**EPA Superfund  
Record of Decision Amendment:**

**Koppers Company, Inc.,  
Superfund Site, (Soil and Groundwater  
Operable Unit) (Oroville Plant),  
Oroville, CA  
8/29/1996**

**AMENDMENT #1**

**KOPPERS COMPANY, INC. SUPERFUND SITE**  
**OROVILLE, CALIFORNIA**

Figure 2-1. Soil unit boundaries in 1989 ROD

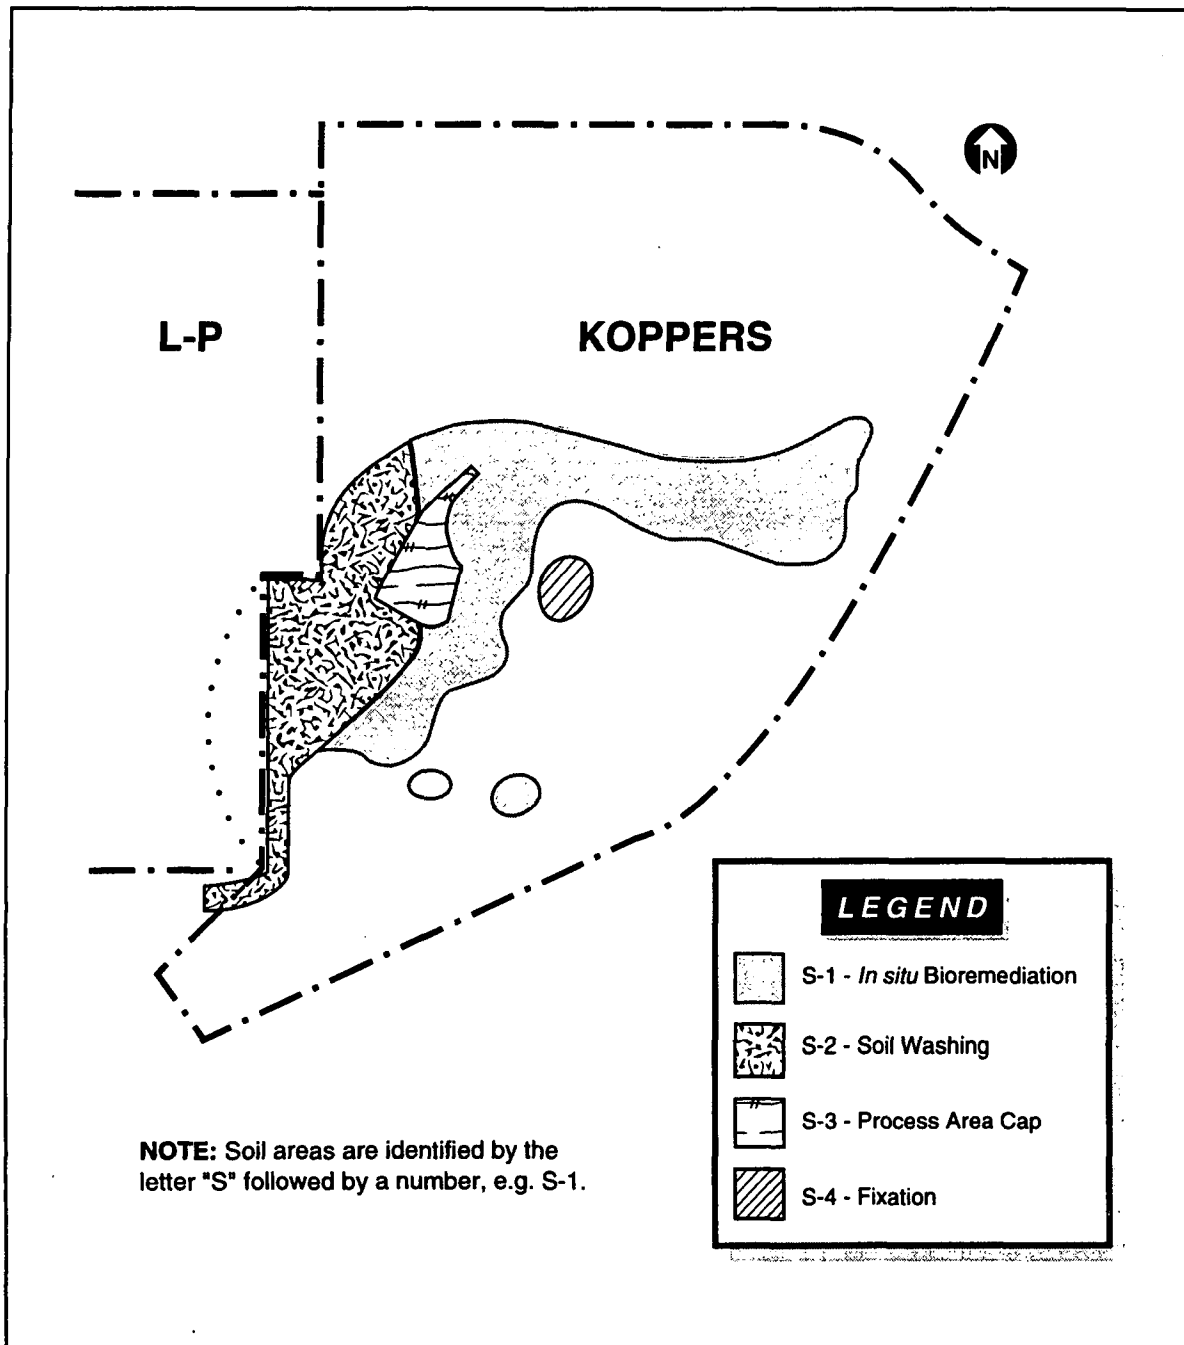
In September 1989, EPA selected soil and groundwater cleanup remedies for the Koppers site. EPA documented the selection of these remedies in an Operable Unit Record of Decision (ROD). The 1989 ROD divided the contaminated soils at the site into four different areas, or units, and selected a specific soil remedy for each unit (see Figure 2-1). EPA selected three innovative technologies as remedies for three of the soil units: *in situ* bioremediation, soil washing, and fixation. The capping remedy selected for the remaining soil unit was designated as an interim remedy that would eliminate exposure to contaminated soil while allowing Koppers to continue plant operations. The area of capped soils was to be cleaned up at a later date, when excavation of the soil would not disrupt plant operations.

Figure 7-1. Areas of soil cleanup

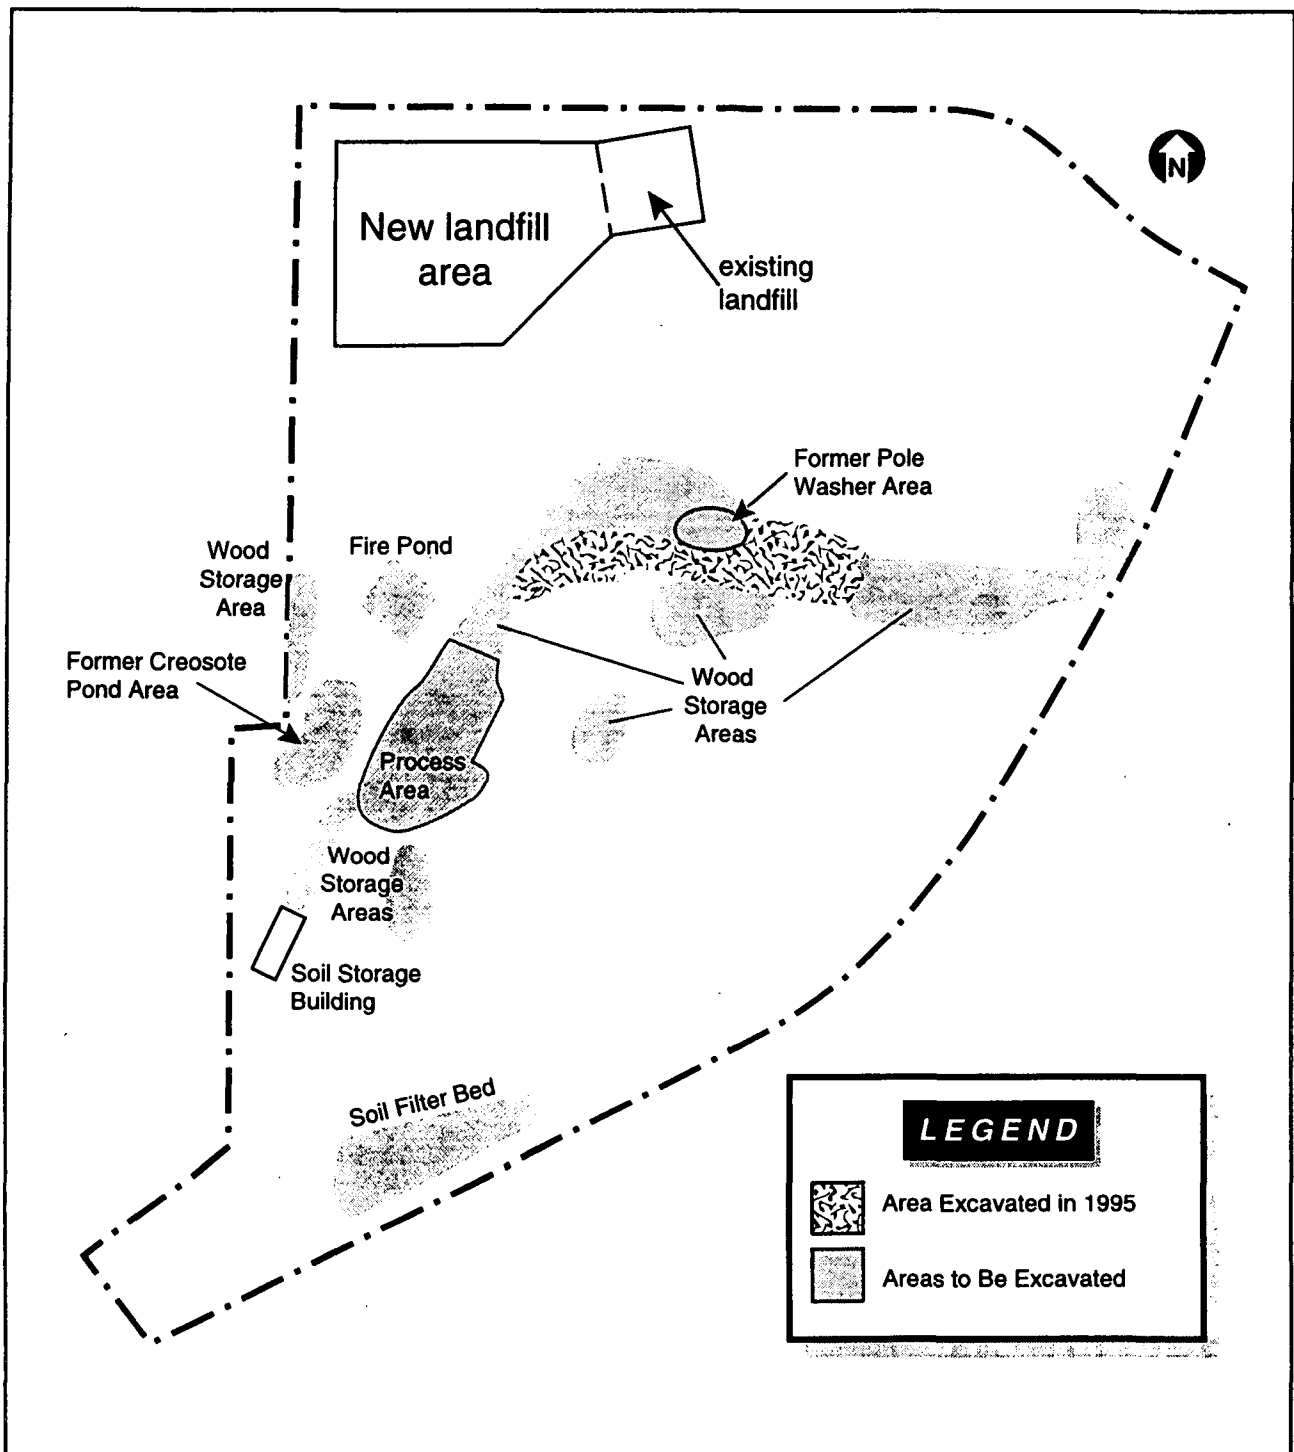
In most areas, soil contamination extends to a depth of one foot or less below ground surface. Deeper contamination exists in the areas of the former creosote pond and the former pole washer. There are also areas of contaminated soil and debris not addressed explicitly by the 1989 ROD which are now being included as part of the overall soil cleanup: 1) the drums of debris from the 1987 post-fire cleanup, which are currently stored on site; 2) the soil filter bed, which was part of a wastewater treatment system; and 3) the sediments in the fire pond. The estimated total area of soil to be cleaned up is roughly 22 acres (including the capped process area), and the estimated volume is 100,000 cubic yards (see Figure 7-1).
